**Early Grading Drainage Report  
Peaceful Ridge at Fountain Valley Subdivision  
El Paso County, Colorado**

PCD File No: EGP-213

Addendum: February 10, 2022

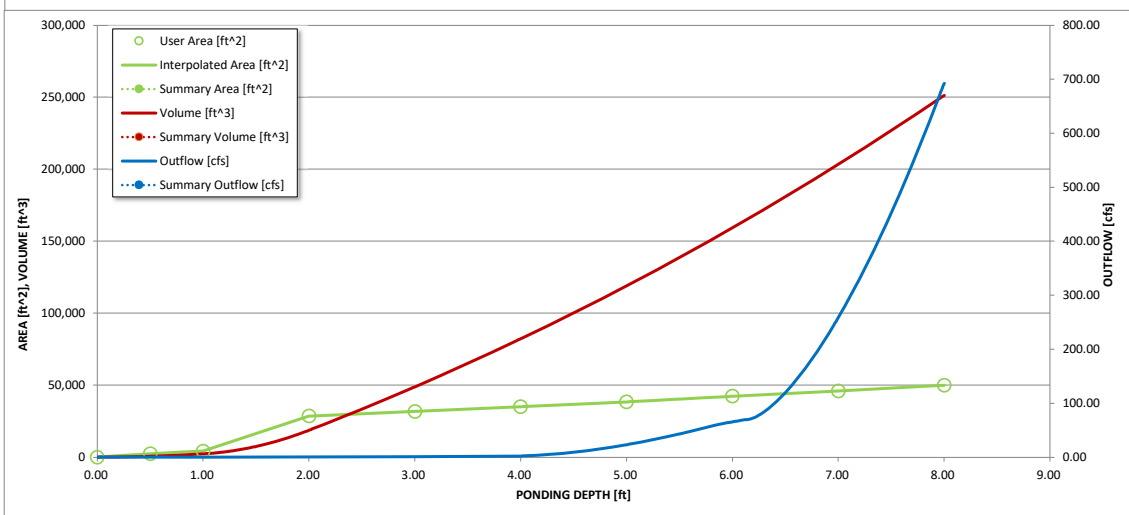
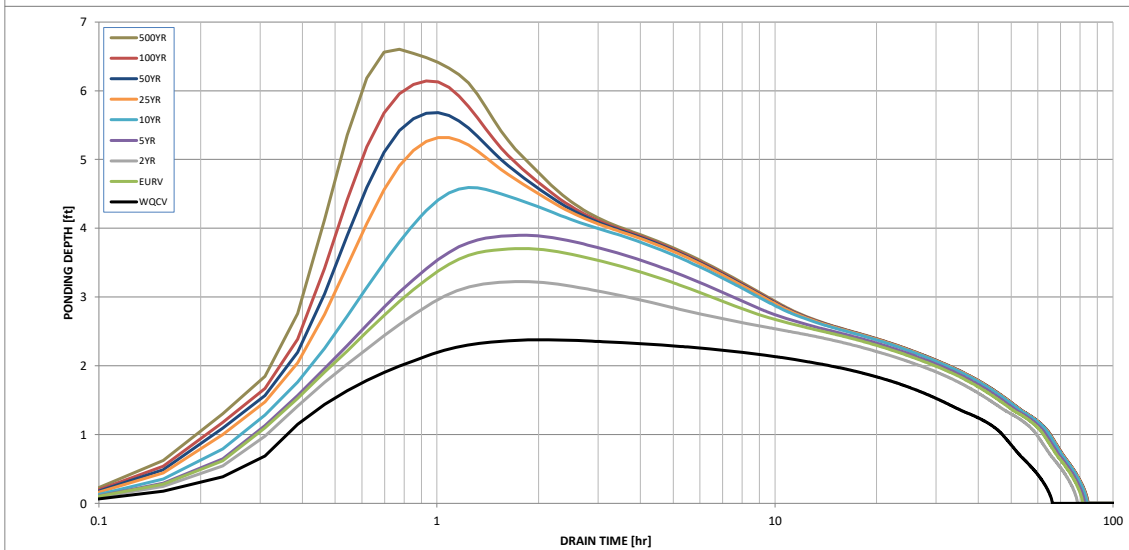
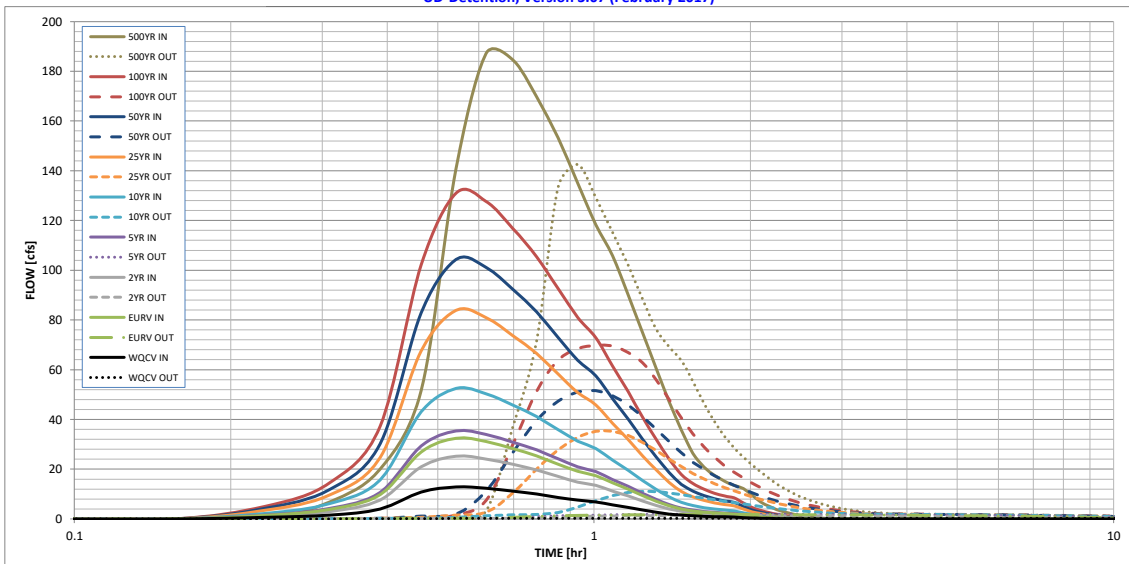
Please revise per Senate Bill 15-212. WQCV should not exceed 40 hours in detention.

Ratio should be less than or equal to 1. unresolved.

SHEET  
**IRF-1**  
 3 OF 3 SHEETS

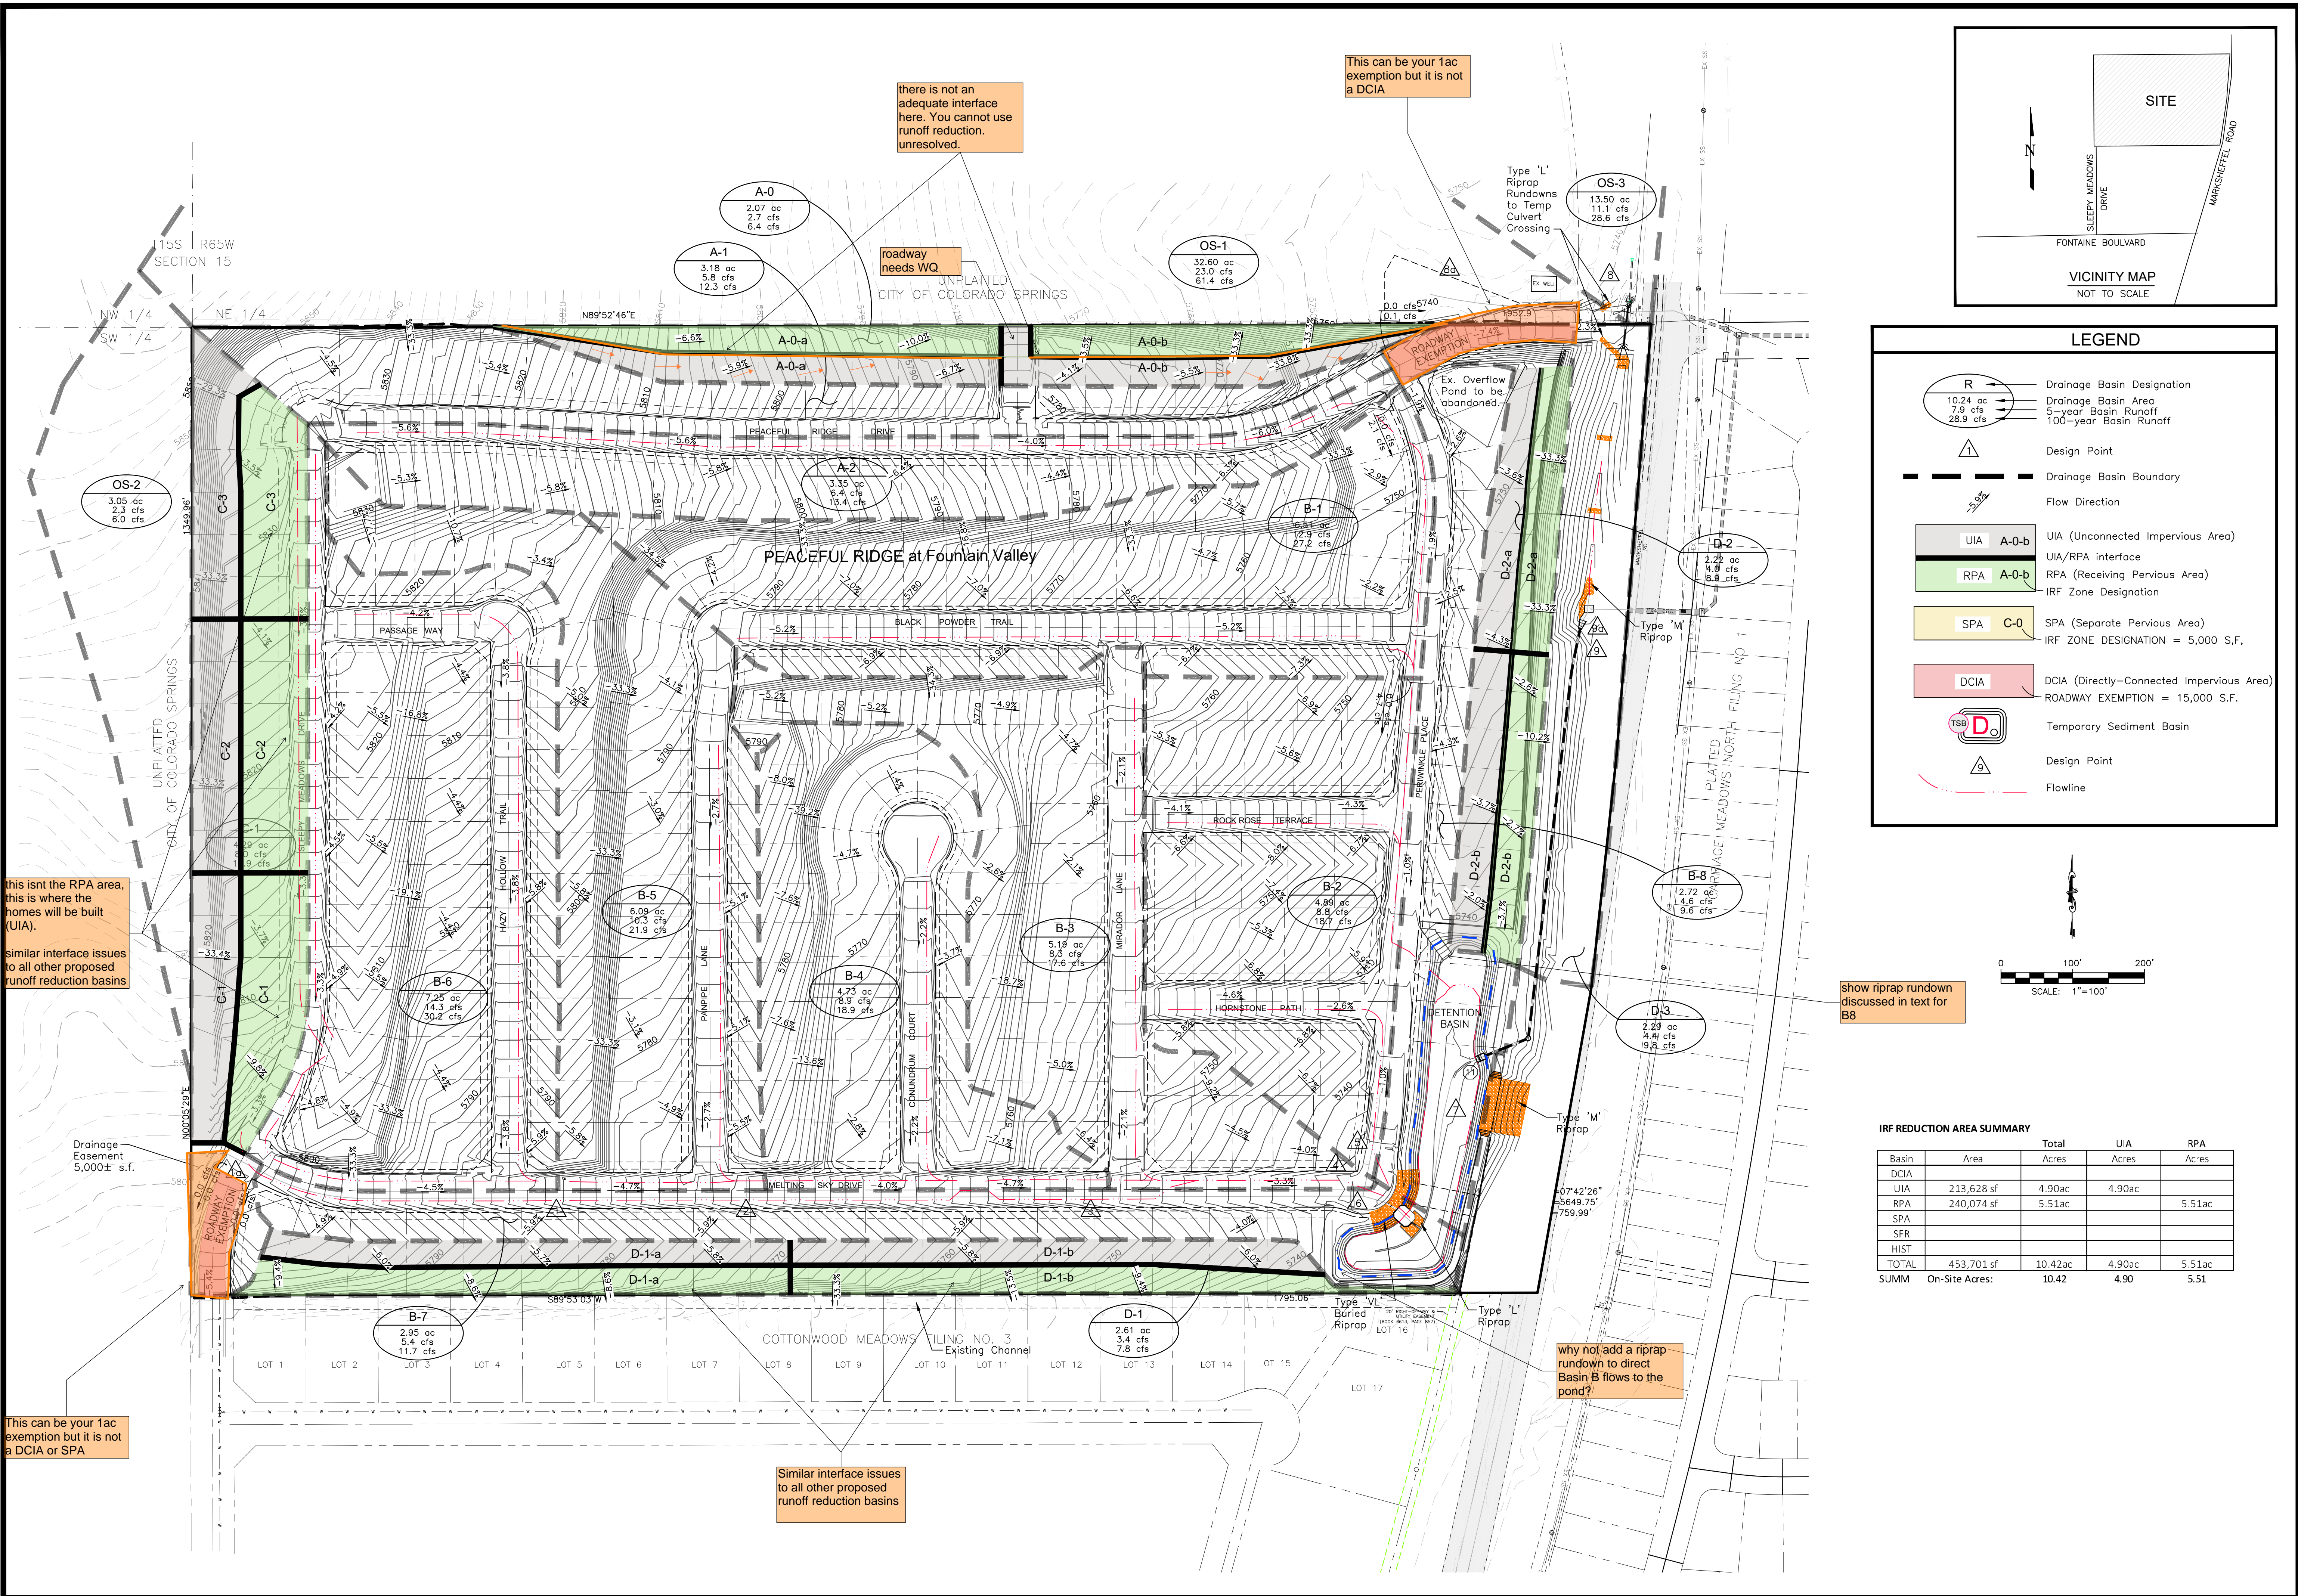
see  
comments  
on IRF-1

Discuss all C basins. i do not believe runoff reduction will work in this area.

see comments on IRF-1

see comments on IRF-1

SHEET  
**D-1**  
 2 OF 3 SHEETS

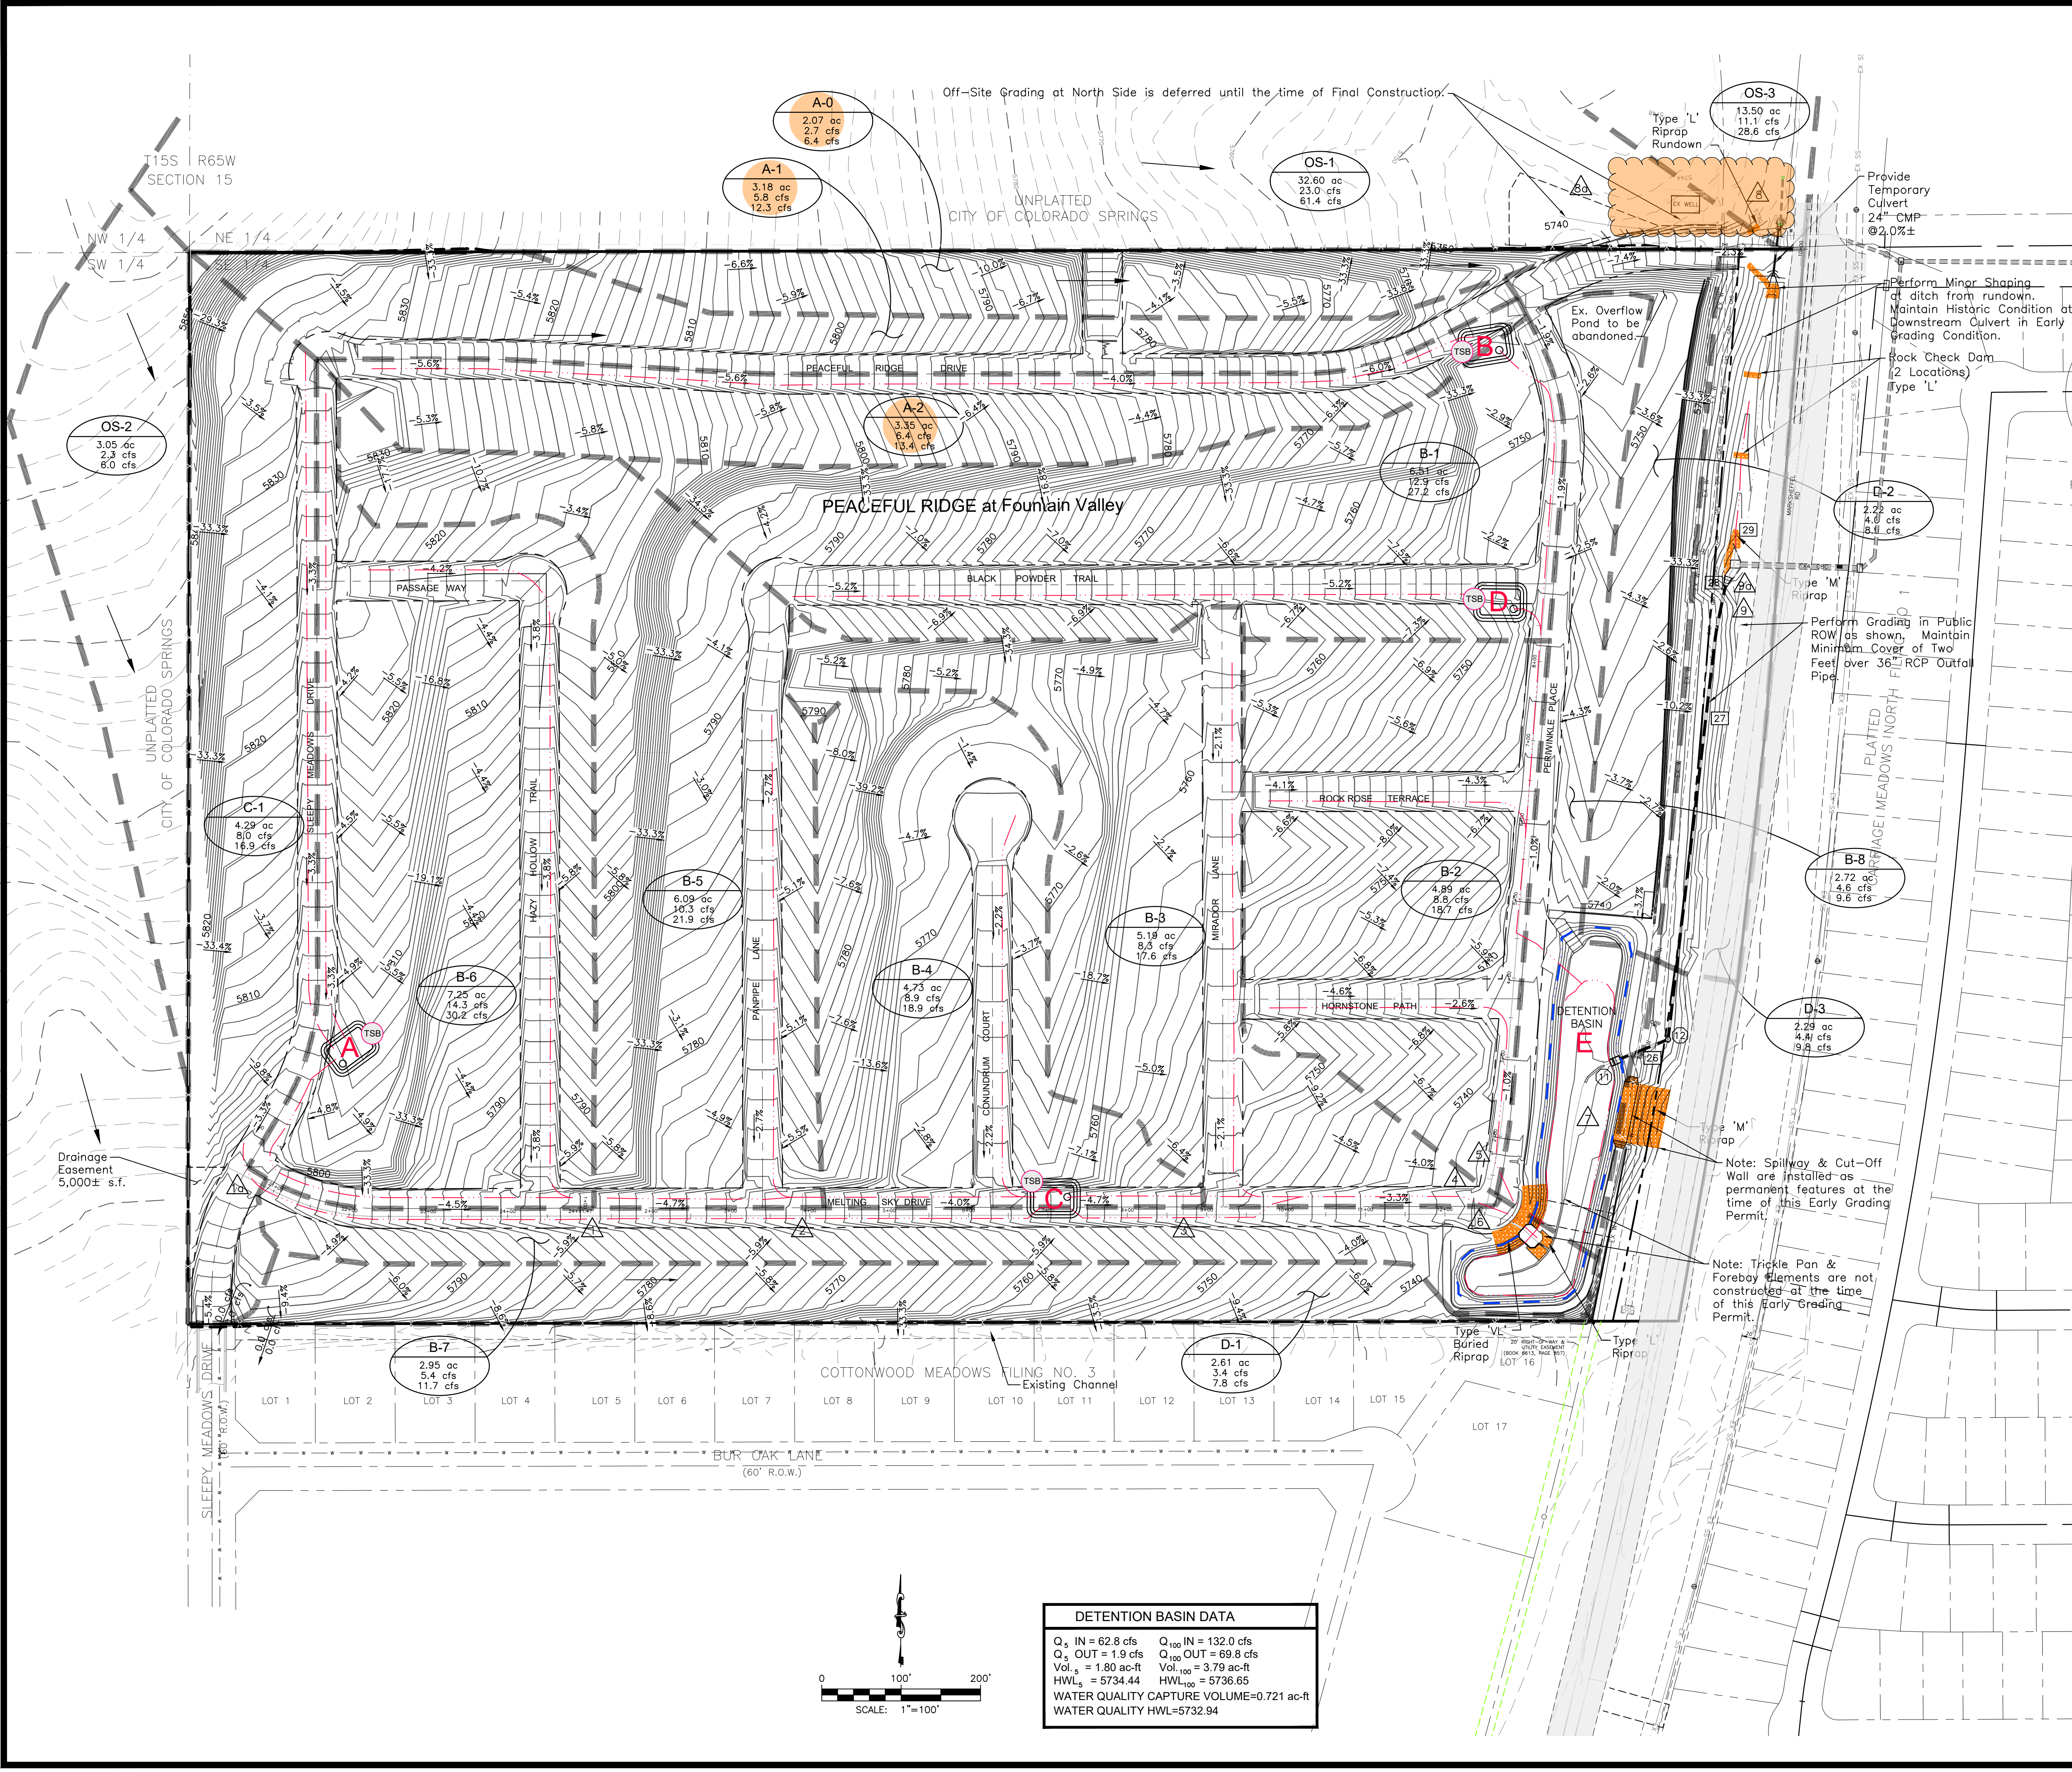
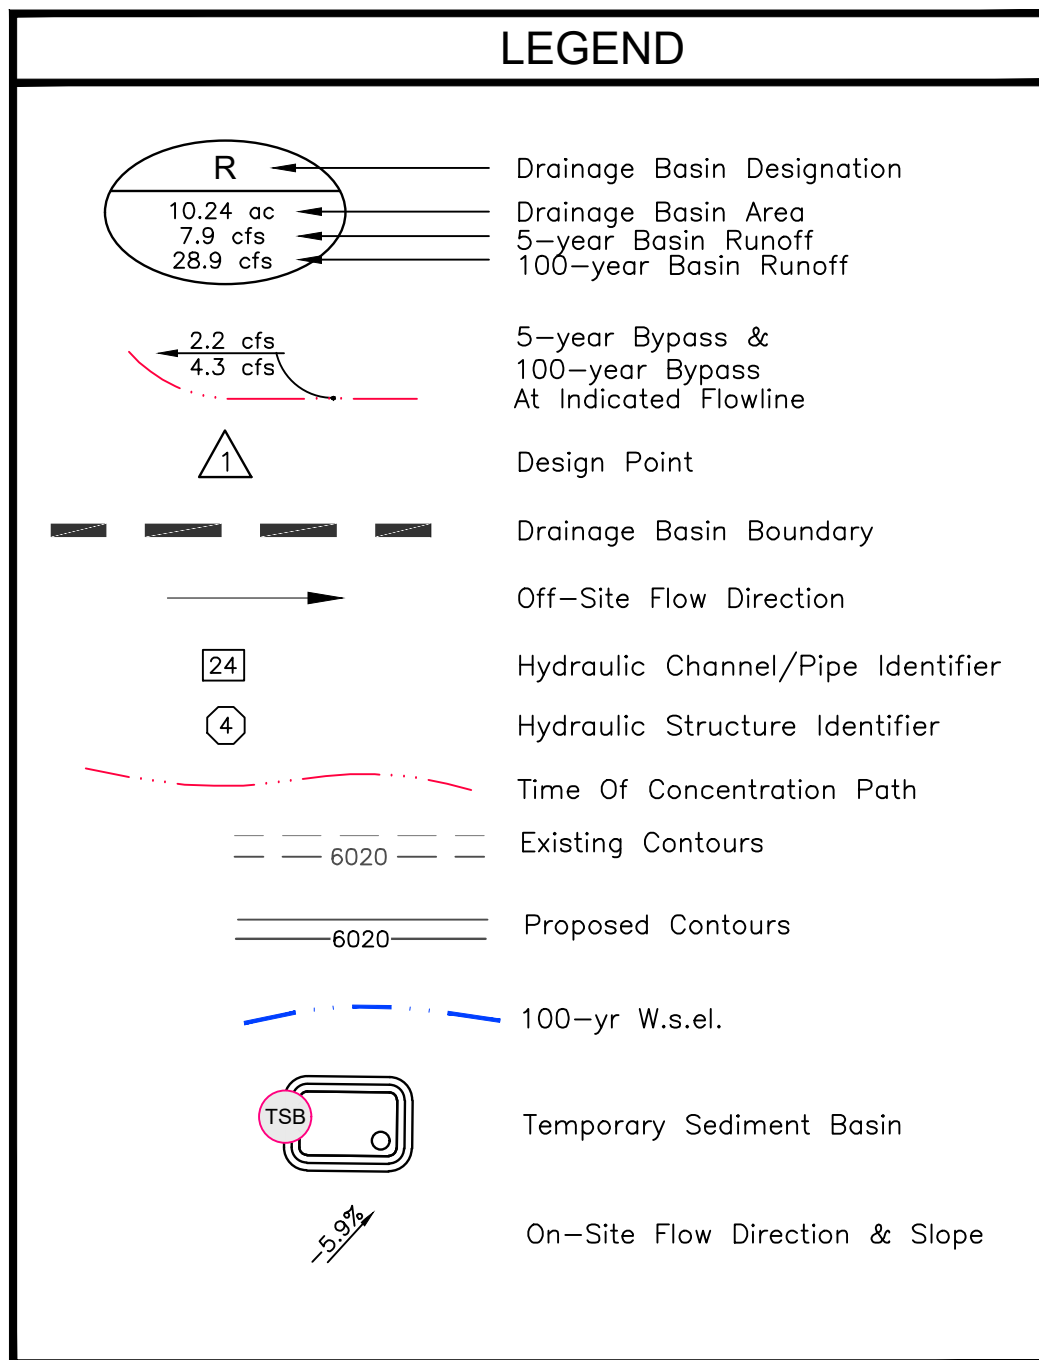
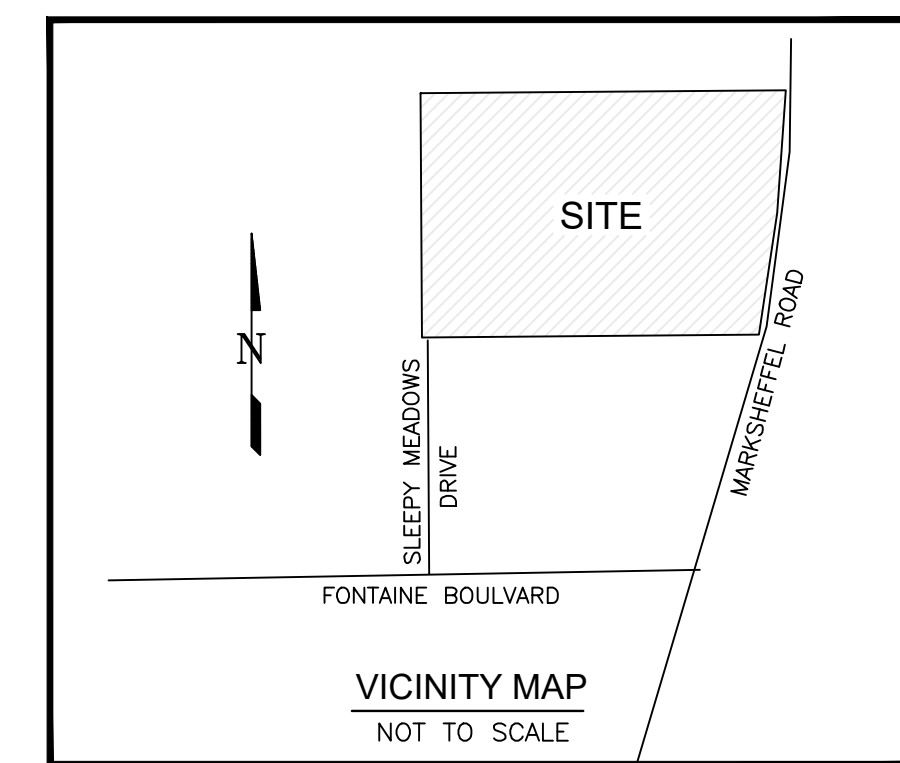
show riprap rundown discussed in text for B8

why not add a riprap rundown to direct Basin B flows to the pond?
